**ADDENDUM NUMBER 02**

**Project No. 22009 / 23007**  
**Sandusky County EMS**  
**Life Squad Station 14 / SCEMS Administrative Offices & Life Squad Station 18**

This Addendum supplements and amends the original Drawings and Specifications dated **October 24, 2024**, and shall be taken into account in preparing bids and becomes a part of the contract documents. Note: this addendum information is issued to bidders of record. It is the prime contractor's responsibility to forward this Addendum information to all affected suppliers and sub/contractors and make adjustments relative to the proposal. Bidders should acknowledge receipt of Addendum on Page BF-1 of the Bid Form, or the last page of this Addendum.

2 TURNOUT / LOCKER ROOM

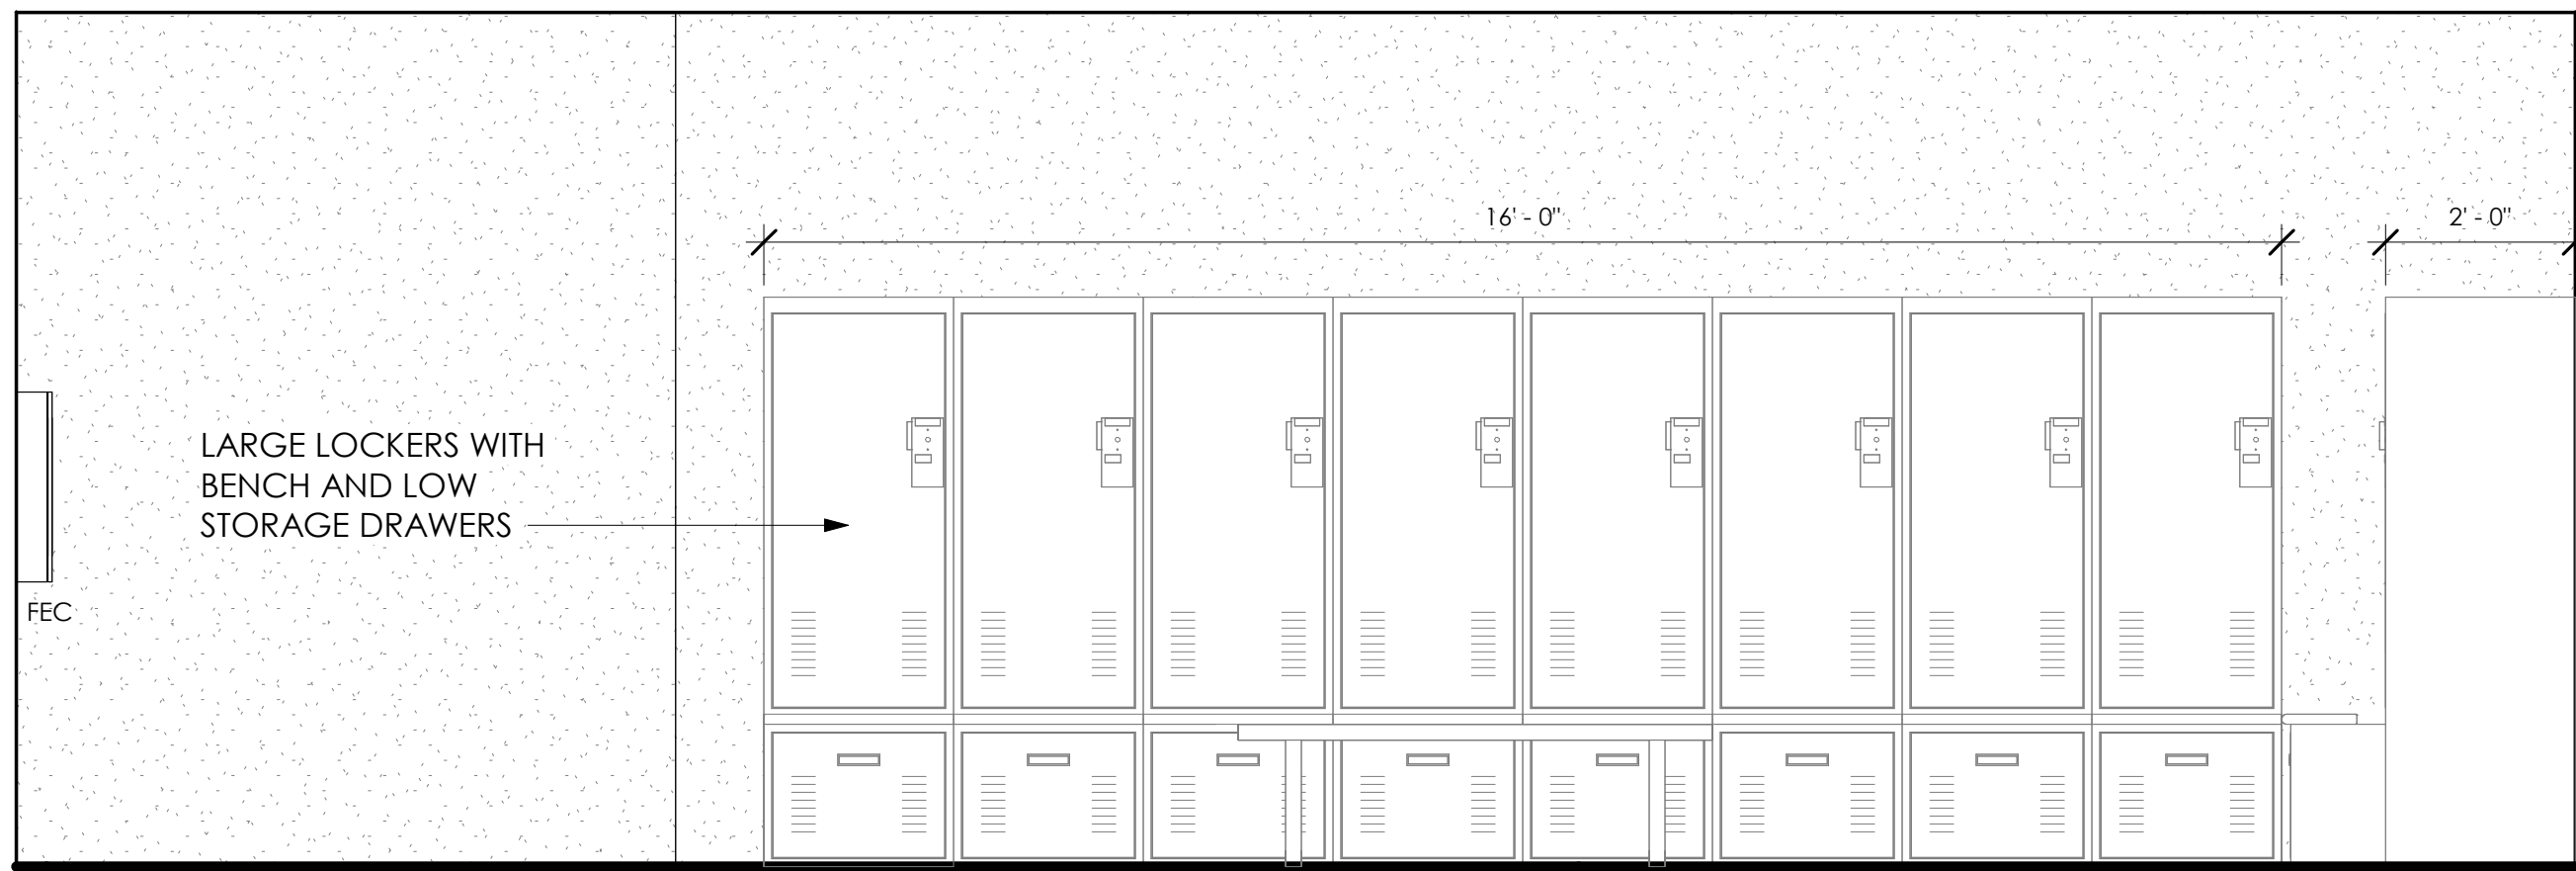
- a. Detail 2/A10.1
  - i. A paper towel dispenser and a soap dispenser have been added to the Turnout/Locker Room
- b. Detail 7/A10.1
  - i. Added note for GB-18 in Men's Restroom 134B
- c. Detail 9/A10.1
  - i. Added note for GB-18 in Women's Restroom 134C.

2 MEN'S REST ROOM 124  
A10.3/ 1/2" = 1'-0"

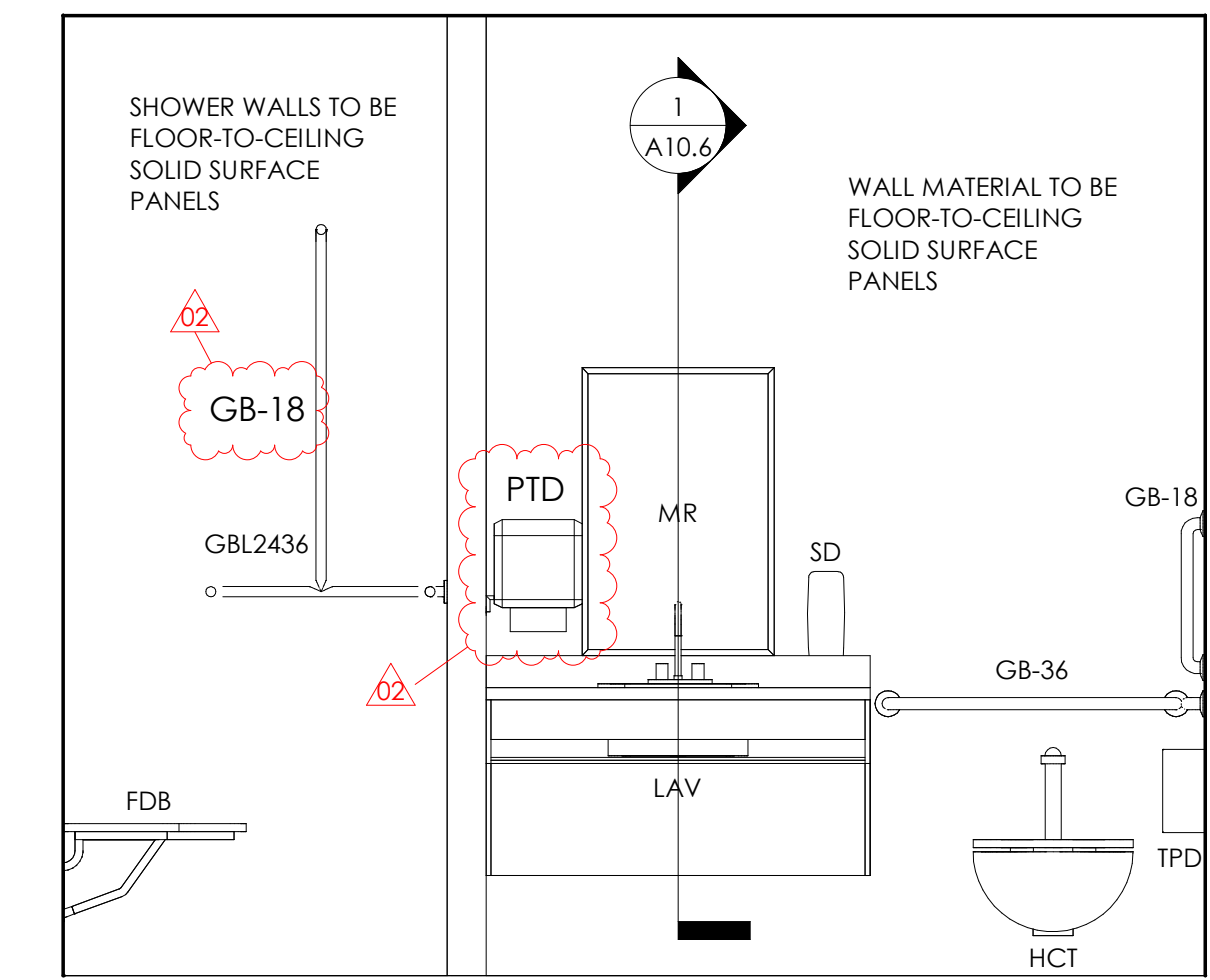
- a. Detail 2/A10.3
  - i. Lockers have been changed to include doors in Men's Restroom 124
- b. Detail 3/A10.3
  - i. A paper towel dispenser has been added Men's Restroom 124
  - ii. Note added for GB-18 in Men's Restroom 124
- c. Detail 5/A10.3
  - i. A paper towel dispenser has been added Women's Restroom 123
- d. Detail 8/A10.3
  - i. A paper towel dispenser and a soap dispenser has been added for Laundry Room 125
- e. Detail 7/A10./3
  - i. Lockers have been changed to include doors in Women's Restroom 123
